Economic Commission for Europe**Inland Transport Committee**

Working Party on the Transport of Dangerous Goods**Joint Meeting of Experts on the Regulations annexed to the European Agreement concerning the International Carriage of Dangerous Goods by Inland Waterways (ADN)****Thirty-second session**

**Proposals for amendments to the Regulations annexed to ADN:
other proposals**

Comments on the English translation of the proposals of the informal working group on Explosion Protection on Tank Vessels (ECE/TRANS/WP.15/AC.2/2018/11)**Transmitted by the Government of the Netherlands****Introduction**

Classification of zones for tank vessels

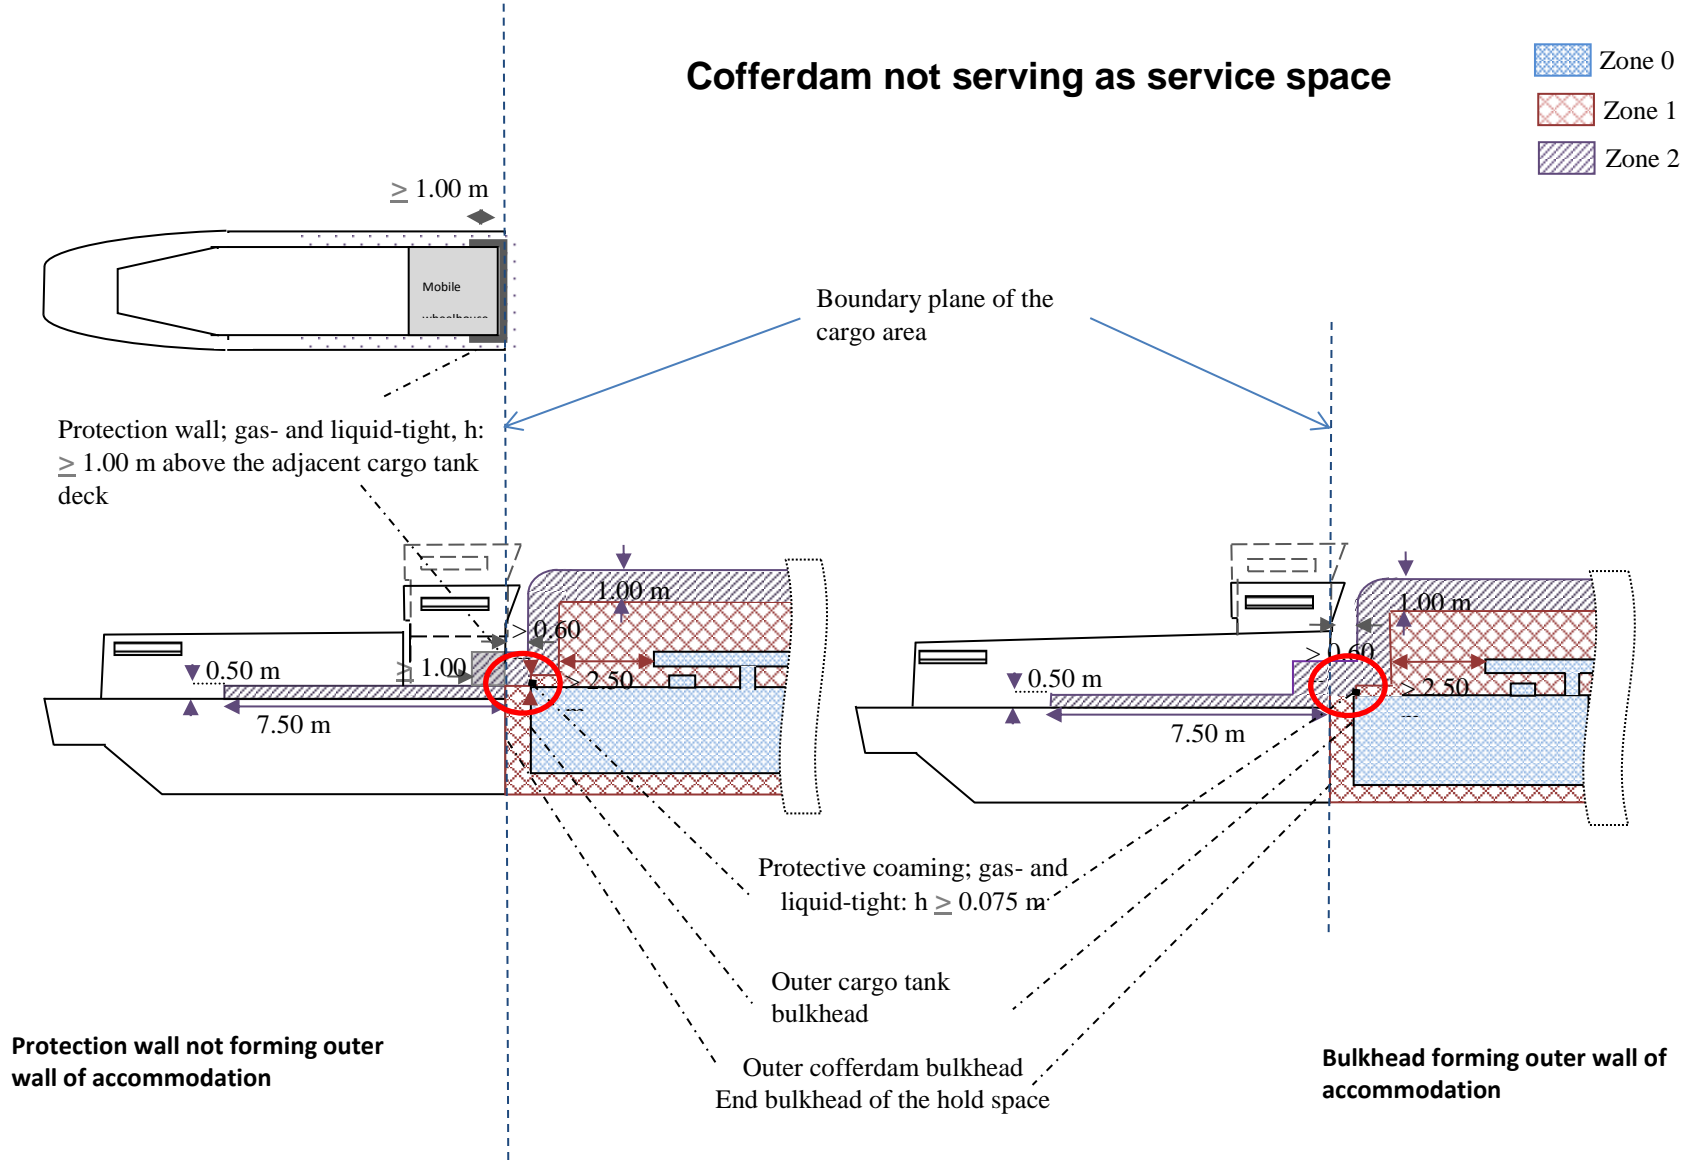
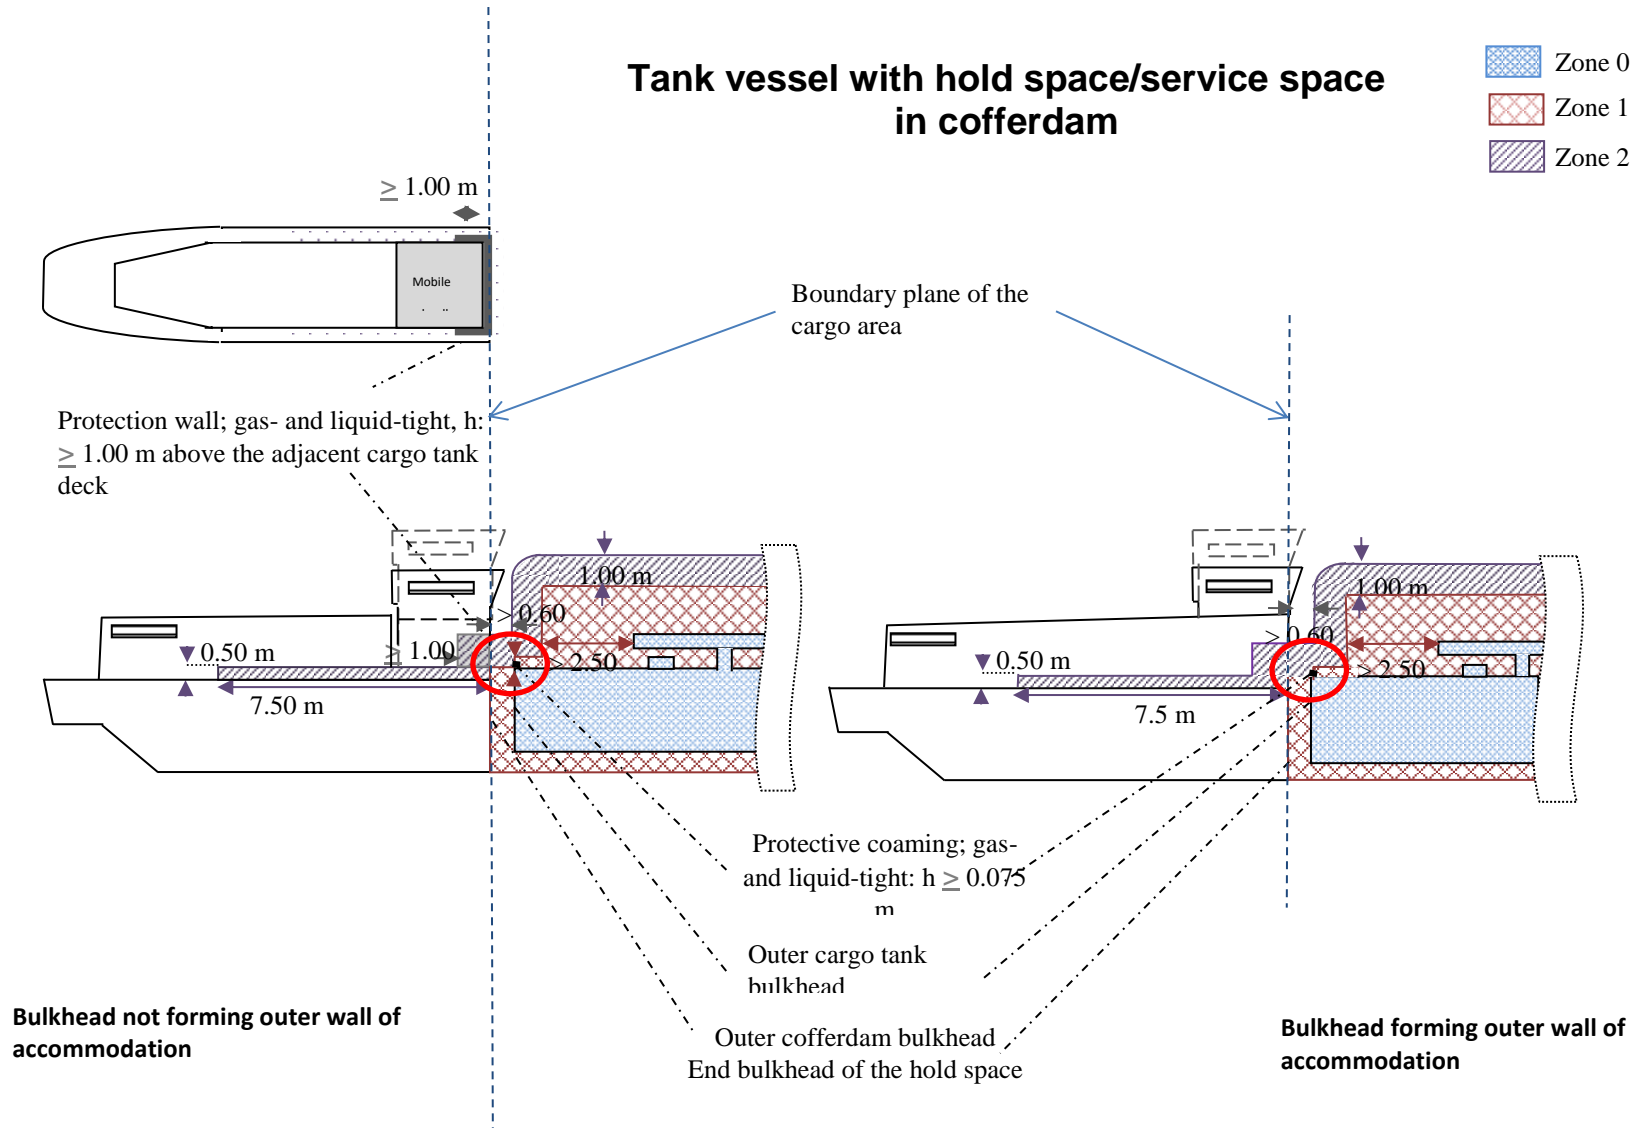
3. Secondly the Dutch delegation would like to draw the attention of the Safety Committee to a small discrepancy between the definition of the classification of zones and the drawings of the classification of zones for tank vessels. In the definition, the third bullet of zone 1 specifies that zone 1 comprises “The deck in the cargo area over the entire width of the vessel to the outer cofferdam bulkheads”. In the drawings however zone 1 is drawn only to the inner cofferdam, as indicated with red circles in the drawings (page 24-26 of this document). The Dutch delegation considers the definition to be leading since this reflects the agreement in the informal working group. The drawing however could be amended and the Dutch delegation therefore asks the Safety Committee to take action as it deems appropriate.
